**City of Rockingham Town Planning Scheme 1
Amendment 295 (Baldivis Town Centre)
City of Rockingham**

**Report and recommendations
of the Environmental Protection Authority**

**Environmental Protection Authority
Perth, Western Australia
Bulletin 906
October 1998**

Figure 2. Indicative Development Plan.

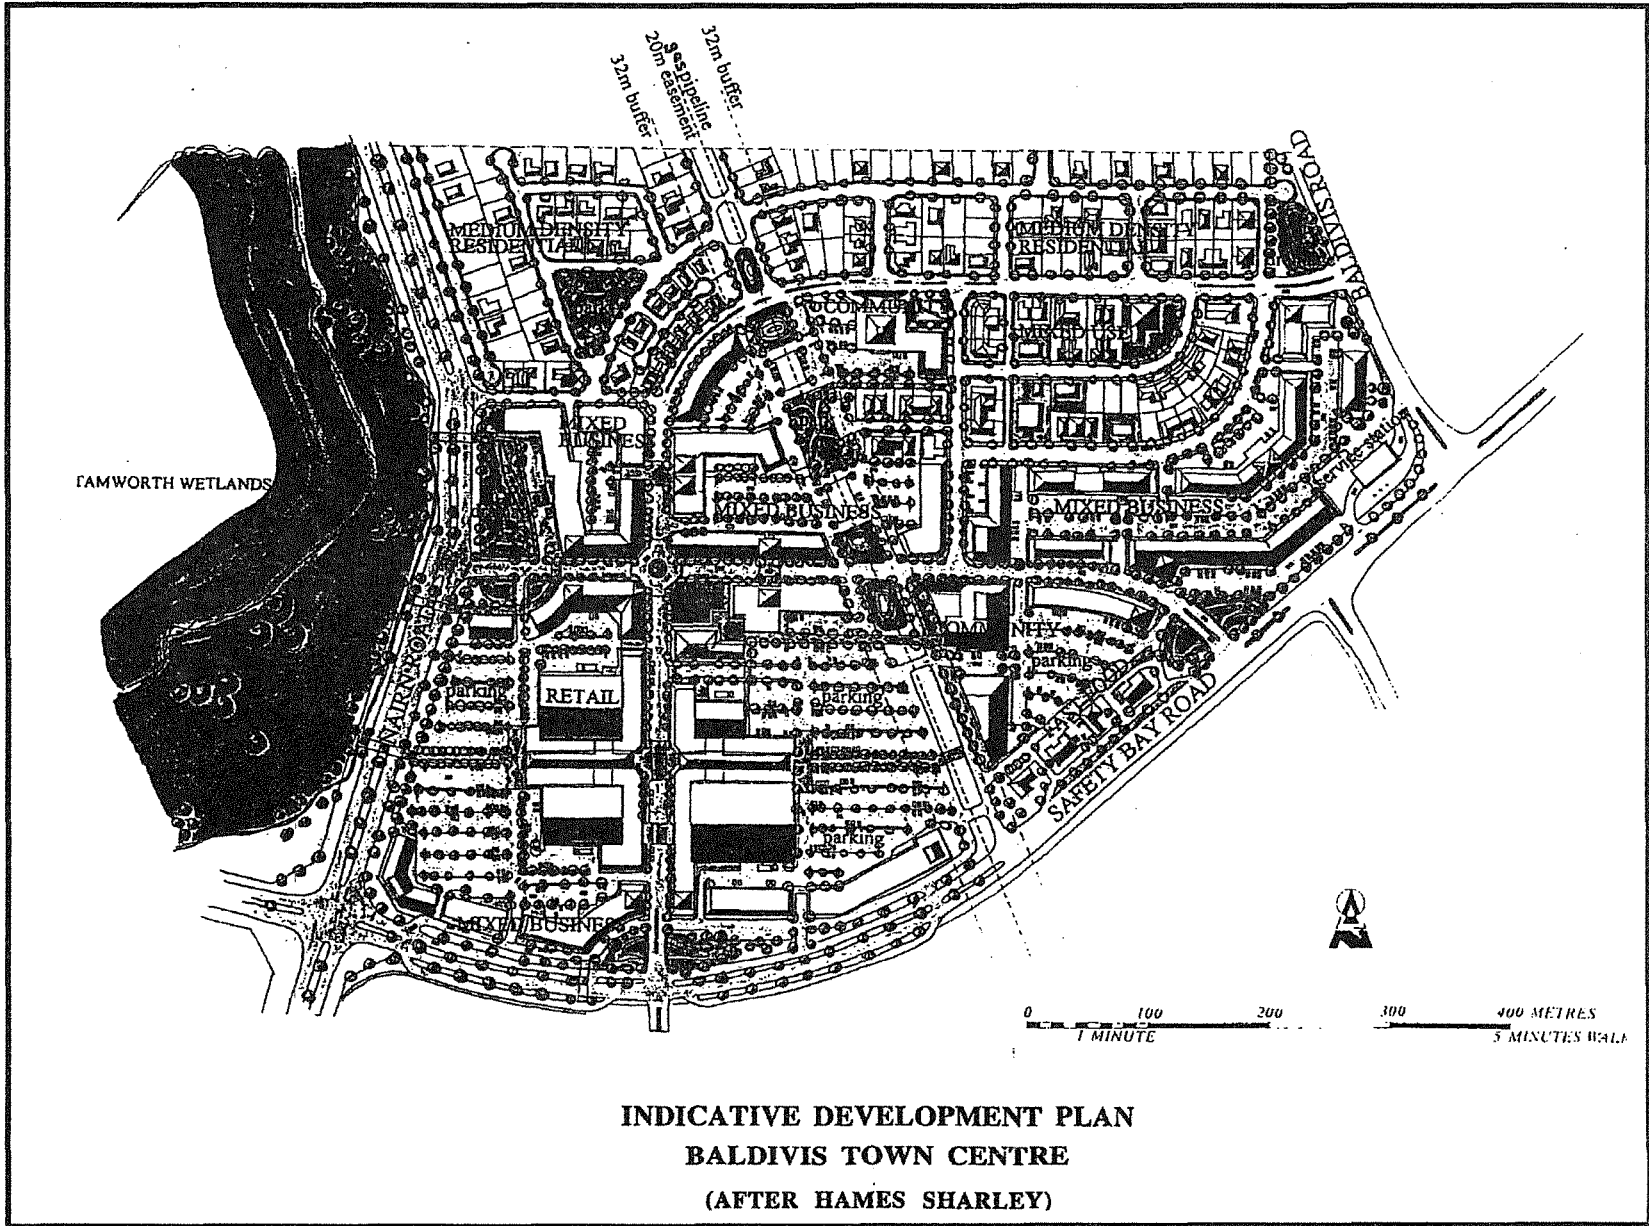
A CMS high pressure natural gas pipeline traverses the site in an approximately northwest-southeast alignment, within an existing 20 m wide easement. The route of the pipeline is clearly visible on the Indicative Development Plan proposed by the City of Rockingham (Figure 2).

There is proposed to be no direct drainage into Tamworth Hill Swamp. Two infiltration basins are proposed, one located on the western boundary of the Amendment adjacent to Tamworth Hill Swamp. The proposed stormwater basins can be seen in the Indicative Development Plan shown in Figure 2.

The proposed location of the stormwater infiltration basin at the western edge of the Amendment, adjacent to Tamworth Hill Swamp, poses some concern to the EPA. As mentioned above the potential pollutants which may be directed to this basin include hydrocarbons, heavy metals and particulates. In the Response to Submissions the City of Rockingham referred to the findings of the Appleyard 1993 report which sought to determine the impact of stormwater infiltration basins on groundwater quality in the Perth metropolitan area. The study monitored bores adjacent to three stormwater infiltration basins with various catchments including a residential area with a light industrial area, a completely residential catchment and one which collected run-off from Leach Highway and a residential area.

The proposed location of this basin is at the lowest part of the Amendment. As the base of the basin will be at or below the water table it is unknown whether the basin will achieve adequate pollutant/nutrient removal. Therefore, it is not clear whether the location and size of the detention basin is appropriate or if the design needs to be modified to be above the water table level. In addition eutrophic wetlands which are unable to dry out during summer provide suitable environments for midges and mosquitoes to breed. The EPA recommends that a Drainage and Nutrient Management Plan be produced to the satisfaction of the EPA, on the advice of the DEP, WRC and CALM which proposes a detailed design for the management of urban runoff which ensures that the rate, quantity and quality of water leaving the Amendment will not adversely impact on Tamworth Hill Swamp, Stakehill Groundwater resource and the Peel-Harvey Estuarine system. The plan will have to consider the biophysical constraints of the Amendment (eg. landform, soil types, hydrology, geology, etc.) to achieve this.

It is recommended that this plan aim to avoid pollutant concentrations close to the wetland by dispersing infiltration of stormwater throughout the catchment. The City of Rockingham has already committed to some of this principle, such as infiltration of roof run-off into localised soakage structures, however the EPA considers that additional Water Sensitive Urban Design principles should be considered, for example flush curbing, grassed swales and roadside soakwells.

The EPA recommends that the preparation of a Drainage and Nutrient Management Plan is an appropriate mechanism for the design and implementation of facilities associated with surface water quality management which can achieve surface water quality objectives for the Amendment. The Drainage and Nutrient Management Plan should include monitoring and contingency provisions in the event that the criteria for water quality and quantity are not achieved.

Figure 4. Tamworth Hill Swamp.

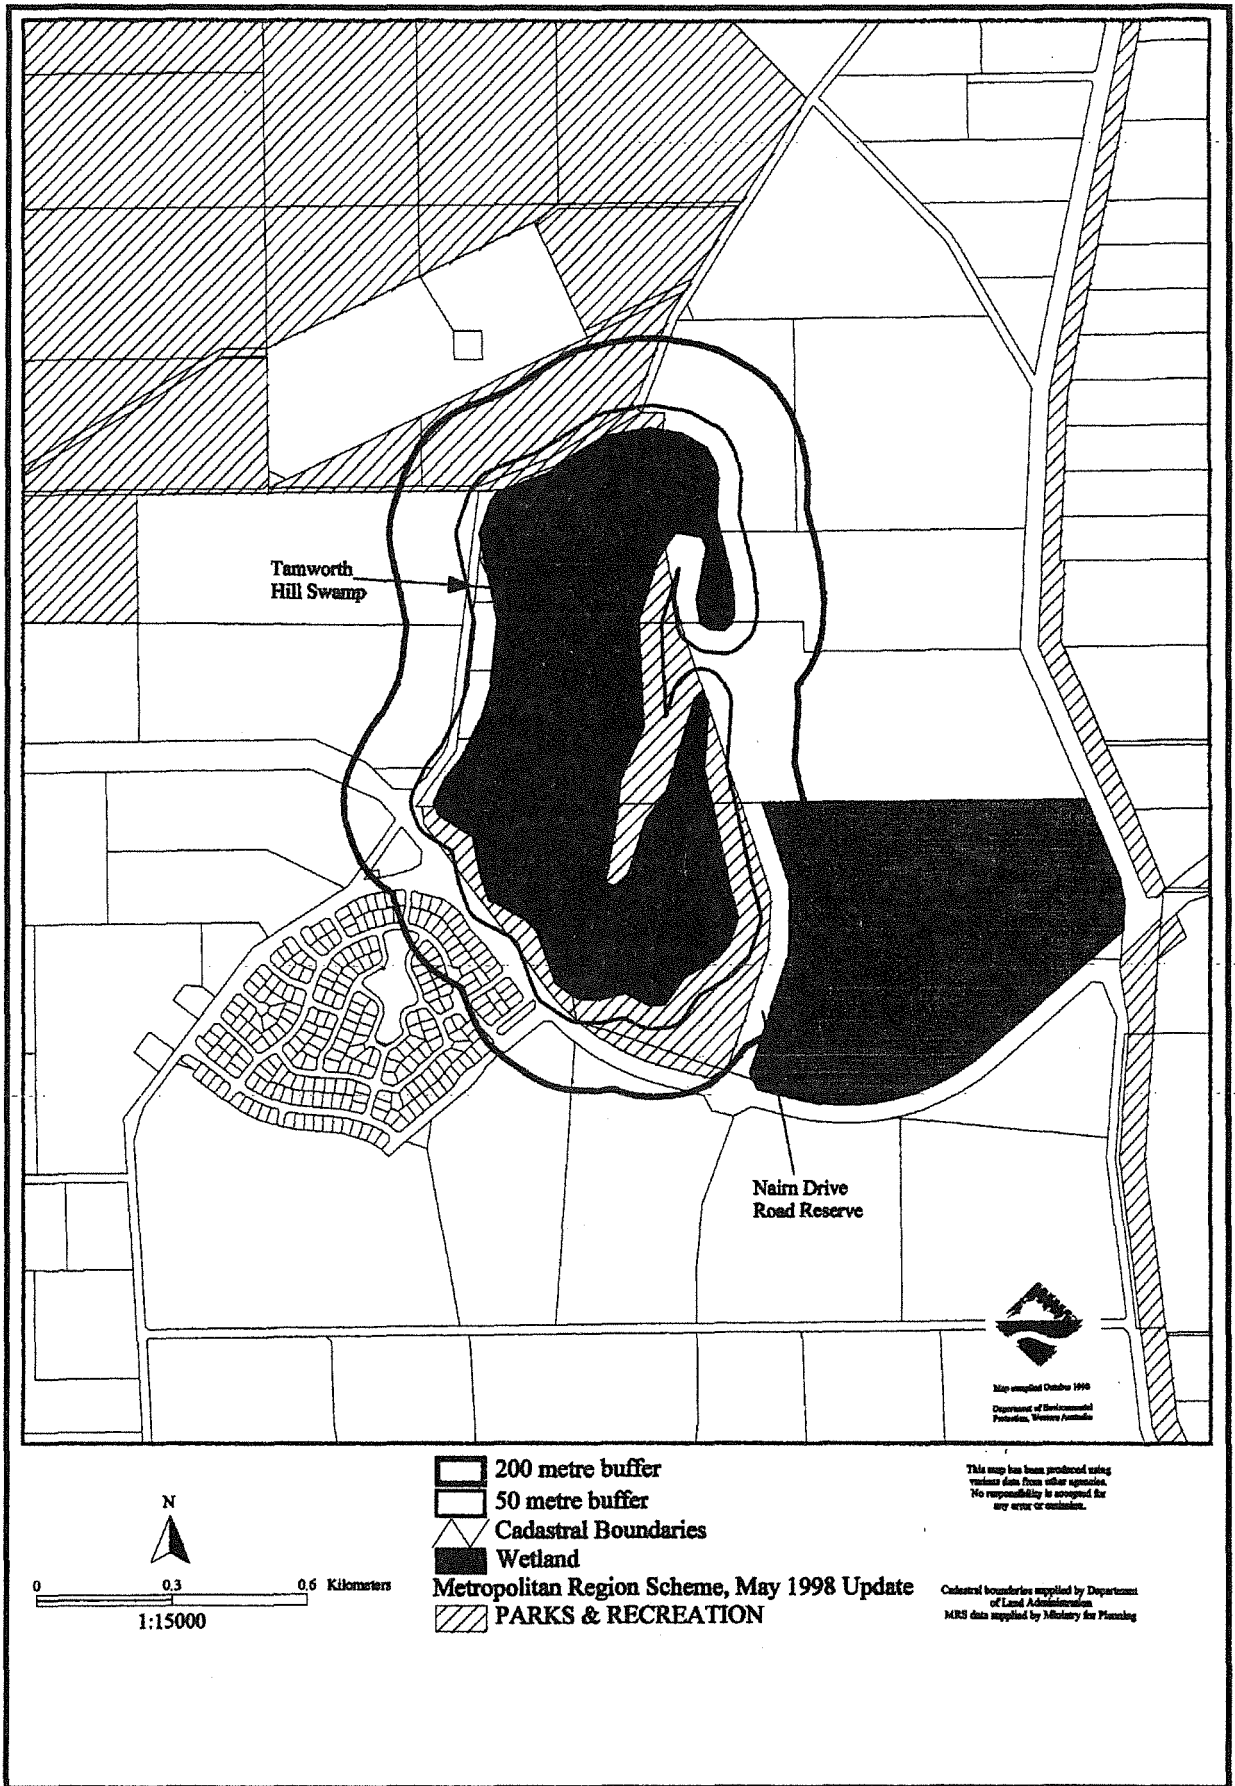
Department of Conservation and Land Management (CALM) recommended a uniform 200 metre buffer. The locations of the 50m and 200m buffers in relation to the Amendment are presented in Figure 4.

In the current Indicative Development Plan for the Amendment area the land uses that are currently shown within the 200m buffer are all sewered and will dispose of all stormwater using infiltration basins, where the closest basin to Tamworth Hill Swamp is 85 metres. On this basis the EPA does not consider the proposed land uses will have nutrient inputs comparable to managed turf or intensive agriculture/horticulture and therefore considers the Davies and Lane recommendation of 200m for nutrient input protection is conservative in this case. Given the proposed high proportion of car parks the EPA considers the pollutants most likely to threaten Tamworth Hill Swamp to be hydrocarbons, heavy metals and particulates, rather than nutrients (McRobert 1997).

The 20-50 metre buffer zone recommended for maintenance of ecological processes and major food-webs by Davies and Lane will be met or substantially exceed by the Amendment in most cases. The EPA would prefer the recommendation to be met in all cases, however given the minor intrusion considers that the existing Parks and Recreation reserve will provide a satisfactory wetland setback for the Amendment.

The EPA considers that the imposition of a condition for a Drainage and Nutrient Management Plan and the Wetland Management Plan will protect Tamworth Hill Swamp from direct and indirect impacts to meet the EPA’s objective of maintaining the integrity, functions and environmental values of wetlands.
